Groundwater Application Review Summary Form

Application # G- 18411

GW Reviewer Phil Marcy Date Review Completed: 5/2/2017

PUBLIC INTEREST REVIEW FOR GROUNDWATER APPLICATIONS

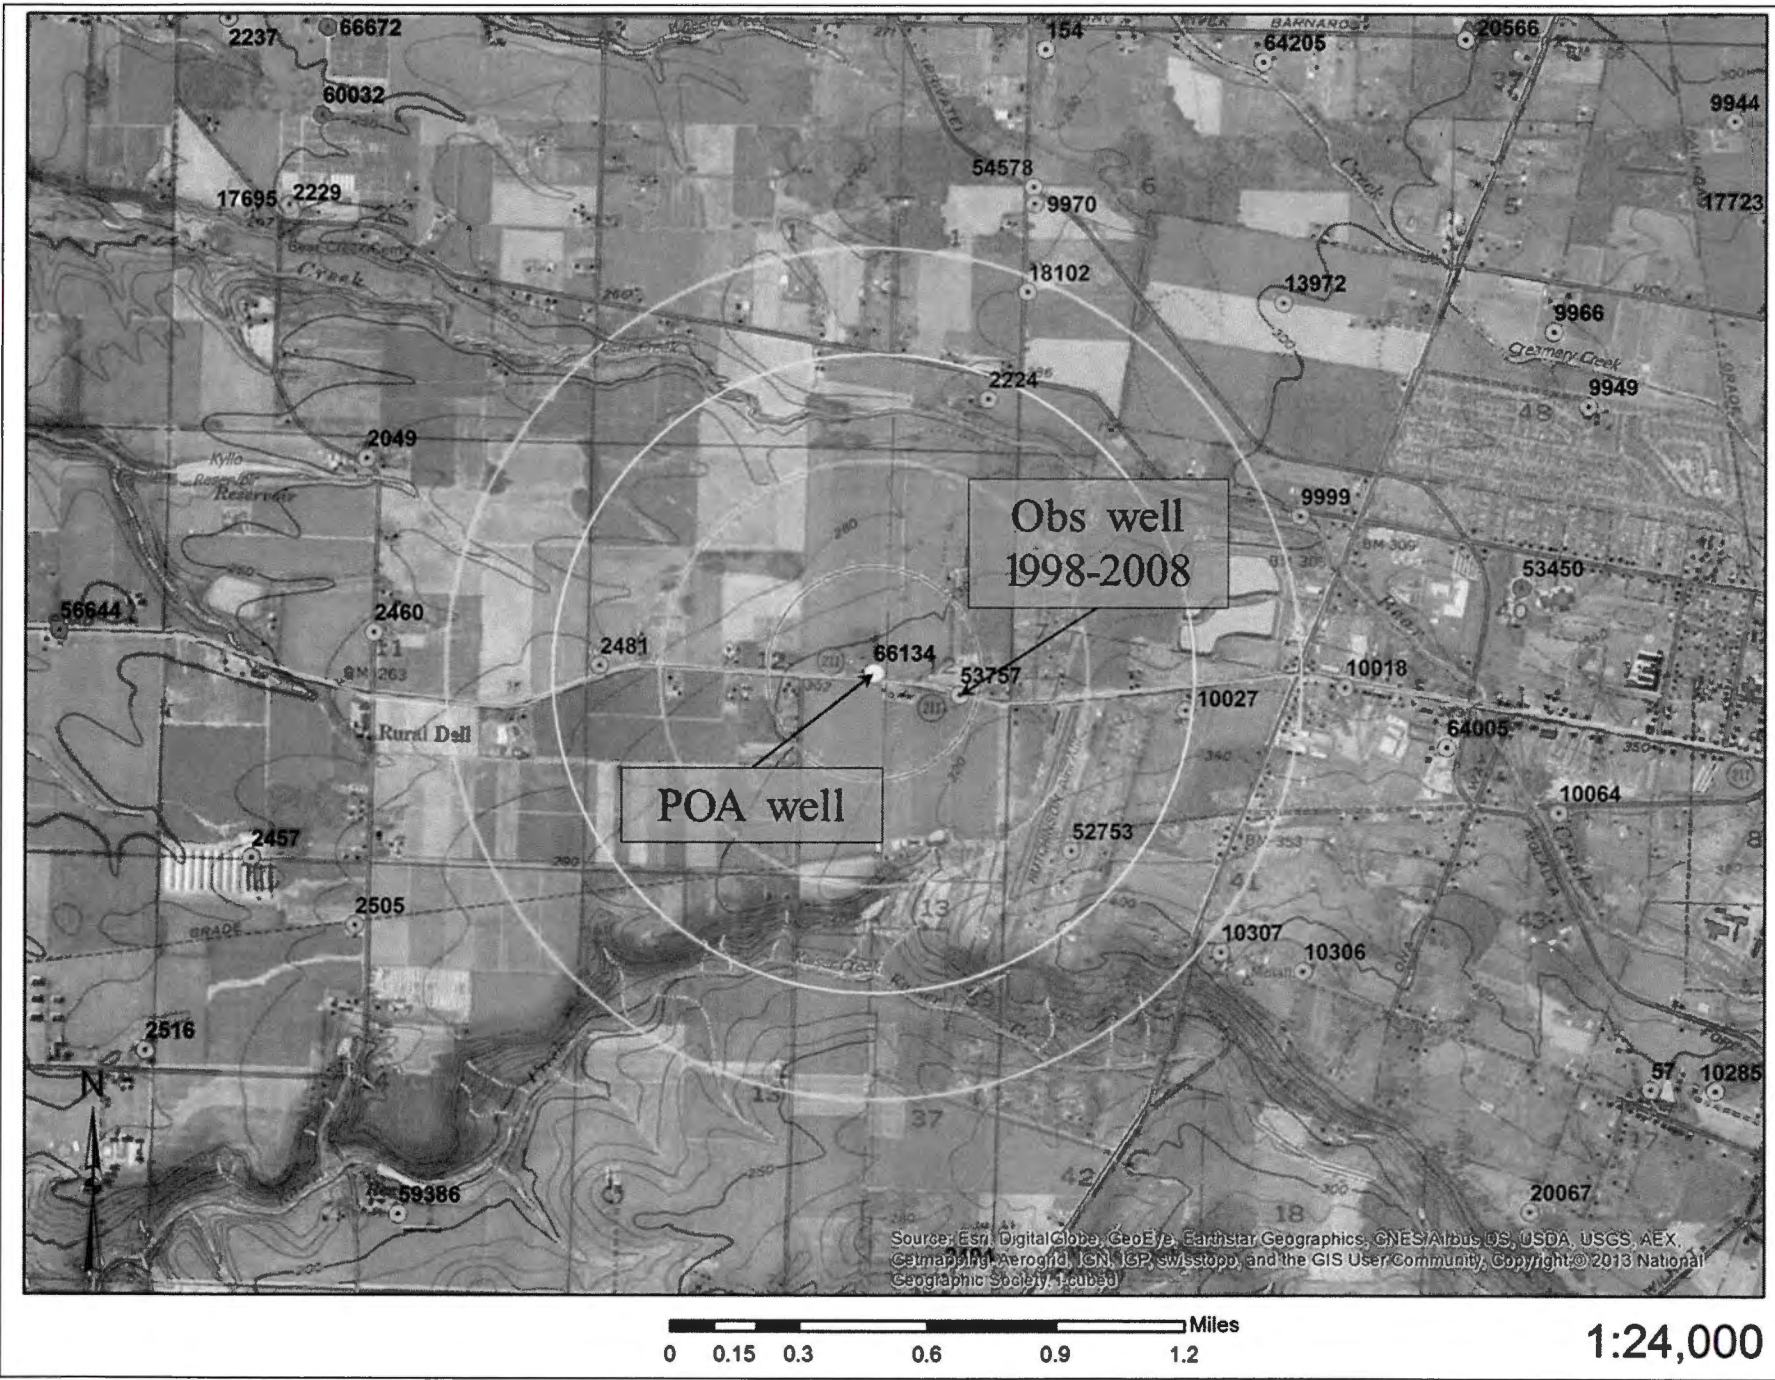
The proposed POA well is currently measured annually under Condition 7C, requiring measurements for a period of 7 years, under permit G-16545. In the attached hydrograph for this well, water levels exhibited a decline between 03/2015 and 03/2016 of greater than 3 feet. While this is not a significant decline and may not illustrate a long-term trend in the local aquifer, the water level trend in the proposed POA well correspond with that of nearby CLAC 53757, whose record spans the period of 1998-2008. Taken together, these records show a decline of ~23 feet over the course of 18 years in this local deep alluvial aquifer system, an indication that the current rate of production is unsustainable. Therefore, I have determined that that groundwater in the proposed aquifer is over-appropriated at the present time, and that the withdrawal of an additional 0.92 cfs would likely only accelerate rates of decline.

If a permit is issued, condition 7N is recommended which requires yearly measurements for the duration of the water right to ensure long-term documentation of groundwater level declines.
